Buckhead CID
West Paces Ferry Safety and Resurfacing Improvements

Addendum #2

West Paces Ferry Rd

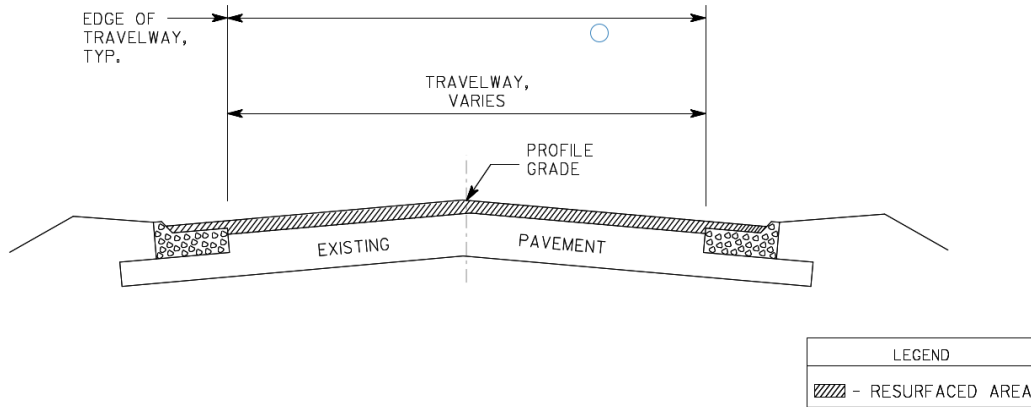
Can you please provide either a typical section for the paving scope or a detailed narrative for the paving scope that explains the expected work scope?

3.2 Miles of Milling, Inlay and Plant Mix resurfacing on West Paces Ferry Rd starting South of the I-75 SB off ramp and extending to Peachtree Rd.

Typical section attached.

This typical section applies throughout the project

Paving Exception – Northside Drive Intersection

Maintain Existing Cross -Slope

Mill Roadway Full Width Variable Depth (4")

Resurface Roadway Full Width with 2" RECYCLED ASPH CONC 19 MM SUPERPAVE, GP 1 OR 2, INCL BITUM MATL & H LIME and 2" RECYCLED ASPH CONC 12.5 MM SUPERPAVE, GP 1 OR 2, INCL BITUM MATL & H LIME

Ensure Smooth Tie-In at All Begin and End Mill Locations
